KC ENGINEERING, INC.

April 2, 2026

RE: Wirtz Dam Road Project

As a result of multiple changes required by Pedernales Electric Co-Op, Inc. (PEC) regarding the electrical conduit to be attached to the bridge, KCE is submitting this proposal to perform the engineering redesign to accommodate changes required by the PEC.

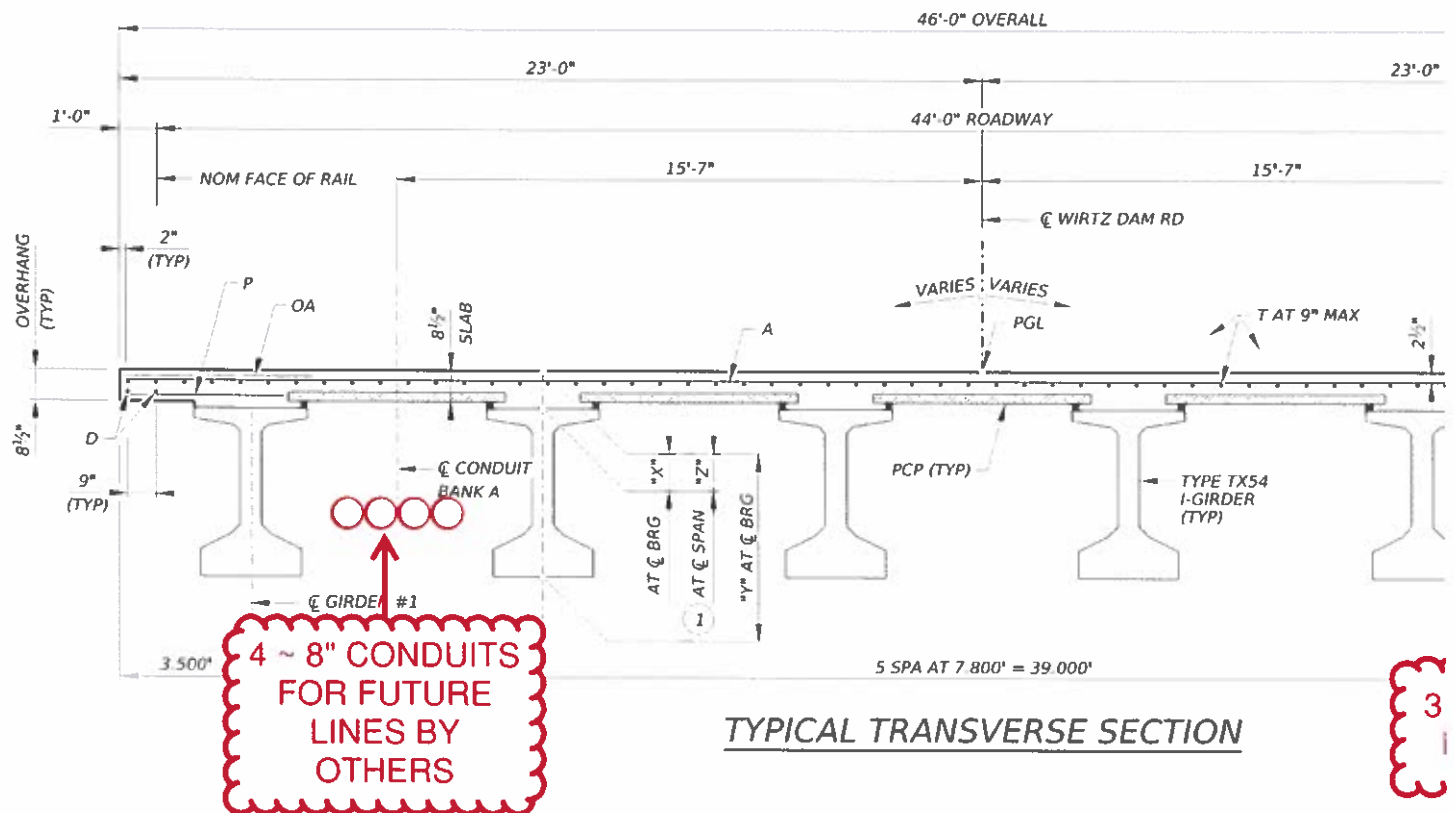
I just realized I can't count... Cross-section below has been updated to reflect correct number of conduits on each side of the bridge. Sorry about that!

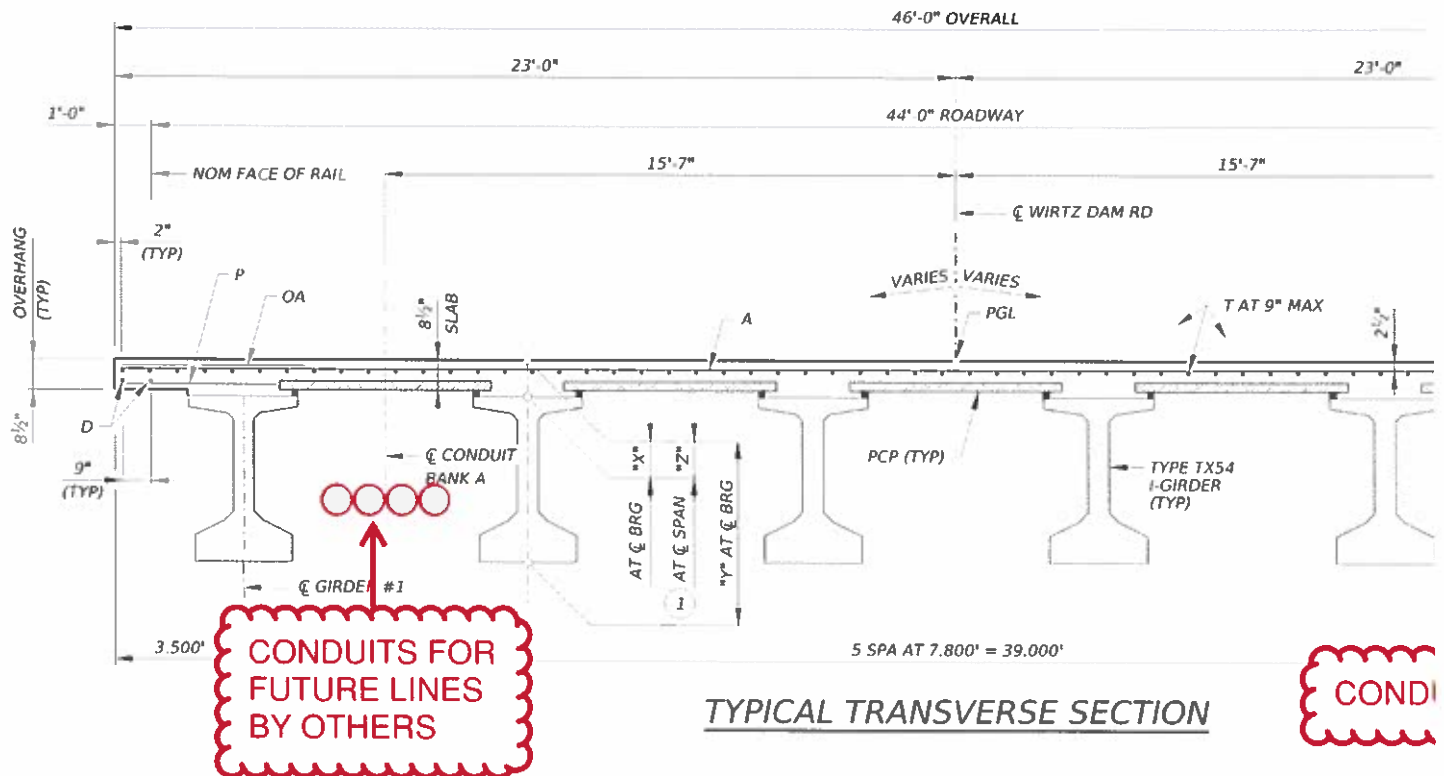
My apologies, I reread your email and realized you had asked about the conduit locations. The PEC lines will be suspended from the bridge deck between the outermost girder and first interior girder – see screenshot of bridge cross-section below. Please let me know if you need any add'l details in order to provide us with the info requested in my original email.

ATTACHMENT A CONDUIT HANGING DETAIL

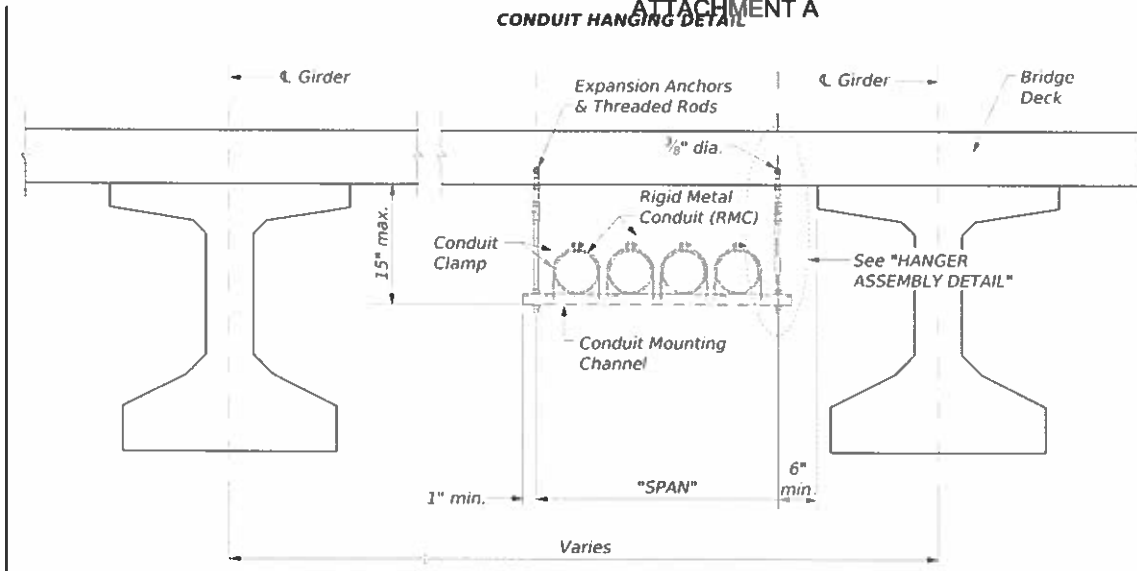
TxDOT has standard details for electrical conduit supported from a bridge, but their details are for much smaller conduit sizes (2" to maybe 6" max) – see screenshot below and attached TxDOT standard. Since these TxDOT details won't work, we're hoping you or PEC has details appropriate for the larger conduit and heavier weights. If not then the support framing will require unique designs and details...
